**ADDENDUM TO THE CONTRACT  
for the  
Auke Bay Elementary  
School Renovation Re-Bid  
Contract No. E12-216**

**ADDENDUM NO.: THREE**

**DATE ADDENDUM ISSUED: March 2, 2012**

2ND FLOOR PLAN -  
TEMPORARY  
VENTILATION  
SYSTEM - PHASE 1

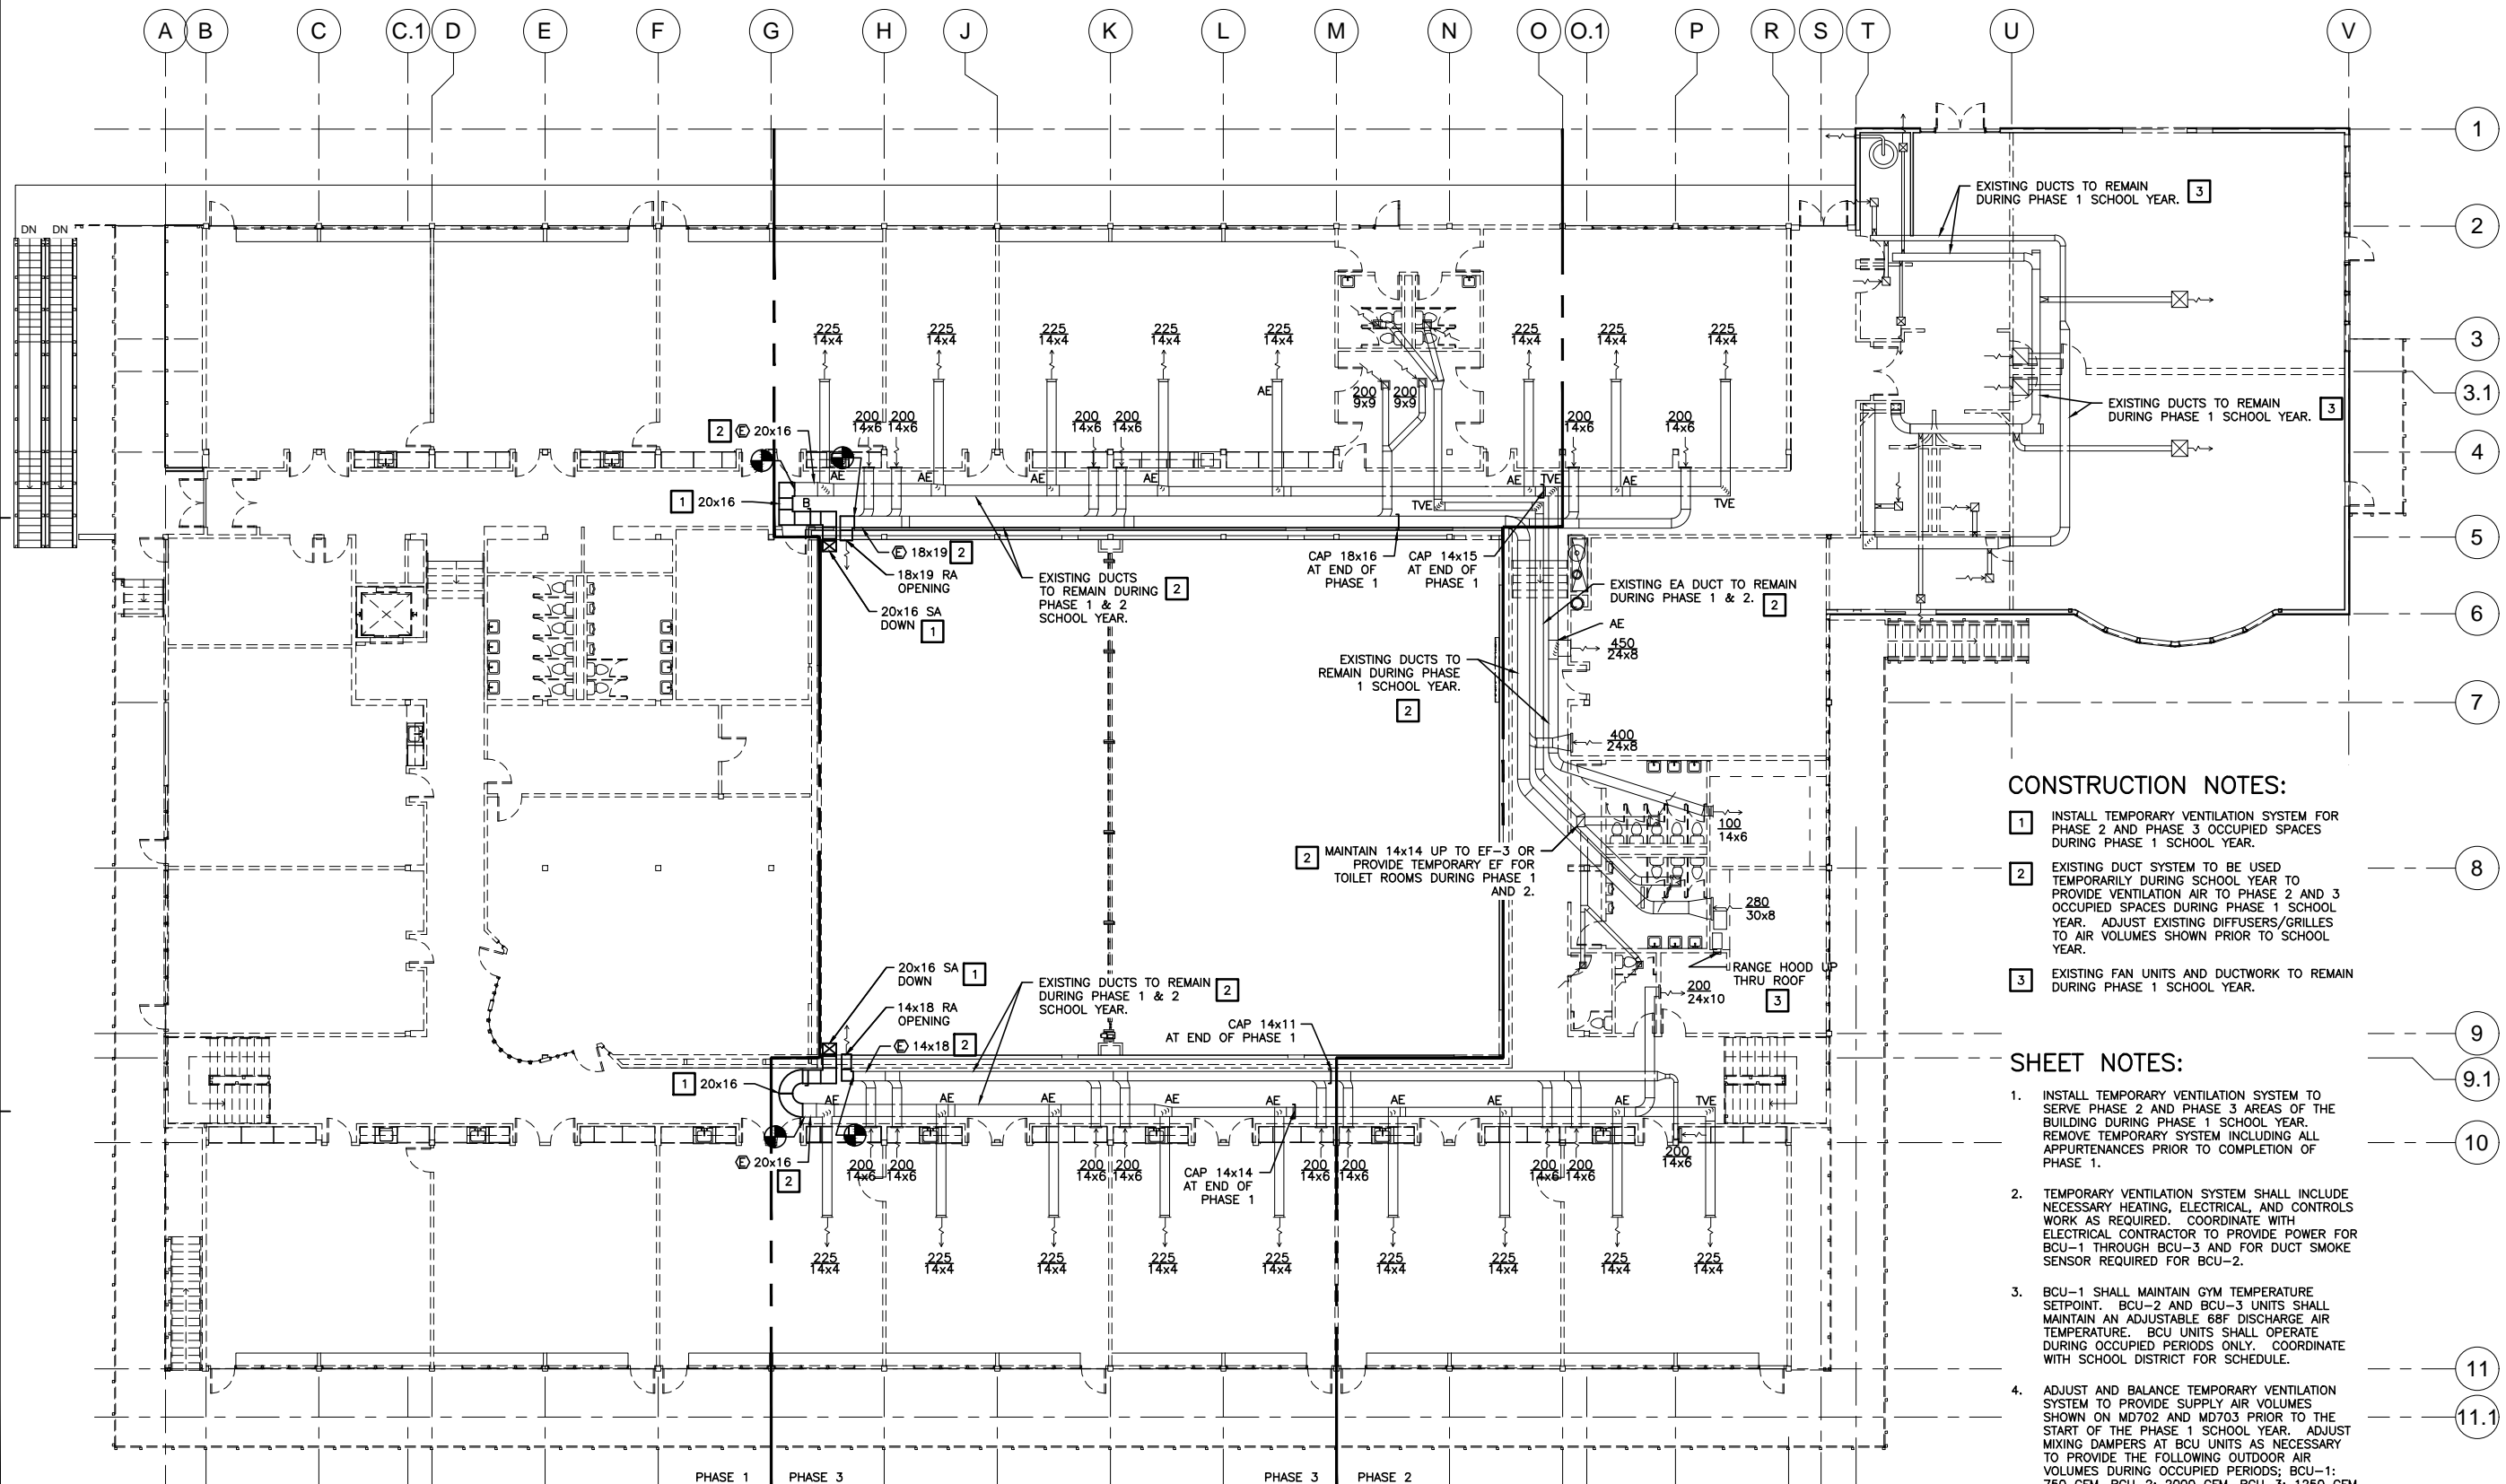
33. Sheet MD703: Add Drawing MD703 labeled addendum 3 (attached). MD703 details the temporary mechanical ventilation system required to provide ventilation to the Occupied Phase 2 and Phase 3 portions of the building during the Phase 1 School Year Construction period. Provide necessary Mechanical, Controls, and Electrical Work as required.

- 1. INSTALL TEMPORARY VENTILATION SYSTEM FOR PHASE 2 AND PHASE 3 OCCUPIED SPACES DURING PHASE 1 SCHOOL YEAR.
- 2. EXISTING DUCT SYSTEM TO BE USED TEMPORARILY DURING SCHOOL YEAR TO PROVIDE VENTILATION AIR TO PHASE 2 AND 3 OCCUPIED SPACES DURING PHASE 1 SCHOOL YEAR. ADJUST EXISTING DIFFUSERS/GRILLES TO AIR VOLUMES SHOWN PRIOR TO SCHOOL YEAR.
- 3. EXISTING FAN UNITS AND DUCTWORK TO REMAIN DURING PHASE 1 SCHOOL YEAR.

- 4. ADJUST AND BALANCE TEMPORARY VENTILATION SYSTEM TO PROVIDE SUPPLY AIR VOLUMES SHOWN ON MD702 AND MD703 PRIOR TO THE START OF THE PHASE 1 SCHOOL YEAR. ADJUST MIXING DAMPERS AT BCU UNITS AS NECESSARY TO PROVIDE THE FOLLOWING OUTDOOR AIR VOLUMES DURING OCCUPIED PERIODS: BCU-1: 750 CFM, BCU-2: 2000 CFM, BCU-3: 1250 CFM.
